WATER LICENCE INSPECTION FORM

Licensee	Licensee Representative
North Country Gold Corp	NA
Licence No. / Expiry	Representative's Title
2BE-CRA	NA
Land / Other Authorizations	Land / Other Authorizations
	--
Date of Inspection	Inspector
September 5,2021	Jonathan MESHER
Activities Inspected	
<input type="checkbox"/> Camp	<input type="checkbox"/> Drilling
<input checked="" type="checkbox"/> Roads/Hauling	<input checked="" type="checkbox"/> Mining
	<input type="checkbox"/> Construction
	<input type="checkbox"/> Other:
	<input type="checkbox"/> Reclamation
	<input type="checkbox"/> Fuel Storage

On September 5, 2021 I Jonathan Mesher A Resource Management Officer of CIRNAC conducted a Water licence inspection at Hayes Camp N66 39’30” W91 32’11”, Bullion Camp N66 23’39” W93 06’55” and Crater Camp N67 22’19” W88 51’24” to ensure compliance with the terms and conditions of the licence 2BE-CRA1520.

Photo 6

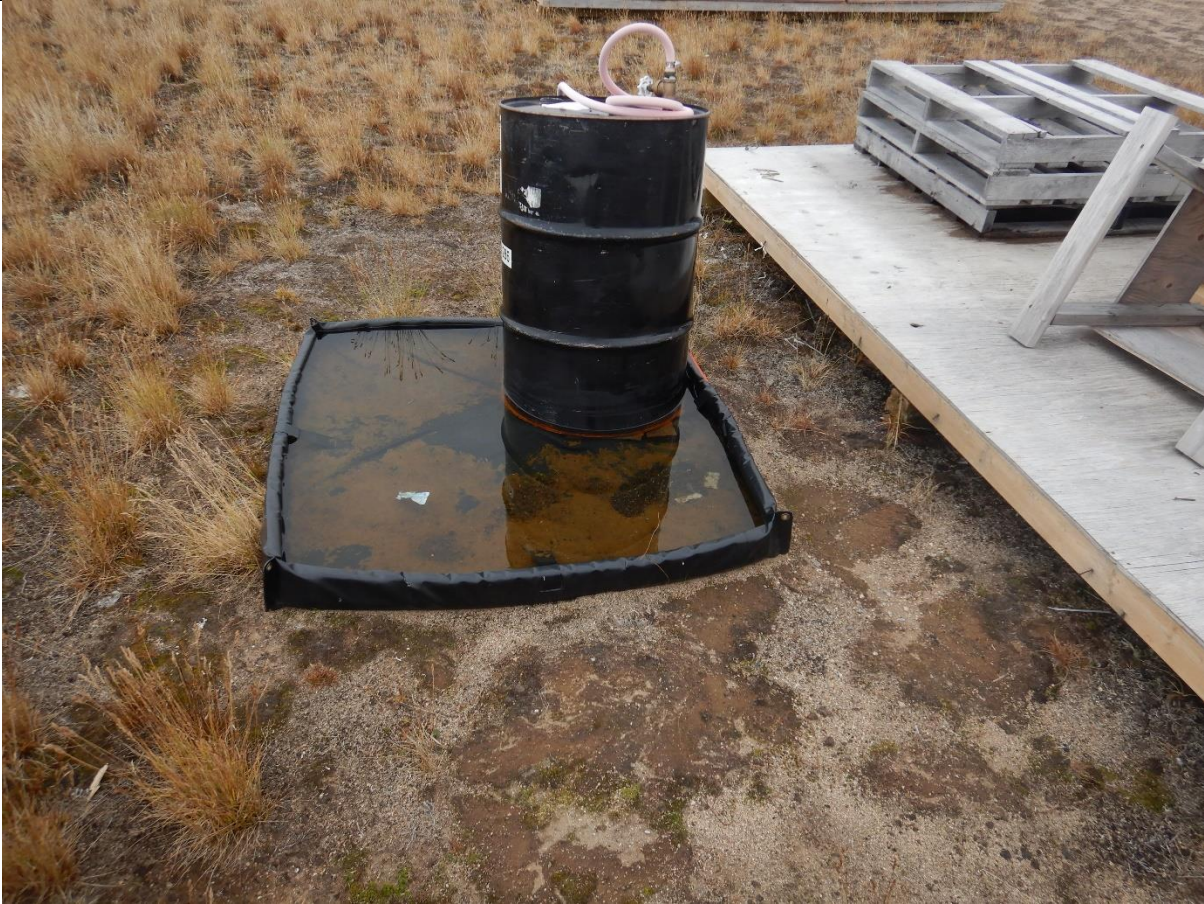
- Section 7 of the Fuel management plan states “NCGC will store all drummed fuel, oils and hydraulic fluids within secondary containment (SEI Industries2 ‘Insta-berms’, Exploration Tents3 berms/trays or equivalent designs). Secondary containment will be capable of holding 110 percent of the volume of the largest fuel reservoir housed within.”, during the inspection the majority of secondary containment was either full with rainwater, damaged and had no secondary containment covers. See photos 3-9 for fuel storage mentioned.

Description: secondary containment full of water.

Section 2	<input type="checkbox"/> Comments	<input type="checkbox"/> Non-Compliance with Act or Licence	<input checked="" type="checkbox"/> Action Required
<p>The following is a list of action required, the licensee is to provide a plan by November 25, 2021to rectify the concerns noted in this section, once the concerns are remediated the licensee is to provide photos with a brief report detailing what work has been done.</p> <div><div>1. The licensee is to ensure all fuel is stored in covered, secondary containment.</div><div>2. The licensee is to ensure the sumps are constructed in a way to prevent the waste from spreading to the surrounding waters.</div><div>3. The licensee is to ensure all sumps are located a minimum of 31m from any water.</div><div>4. The licensee is to remediate the erosion noted in comment B1 at Haynes Camp.</div></div>			
Inspector's Name			
Jonathan MESHER			
Signature
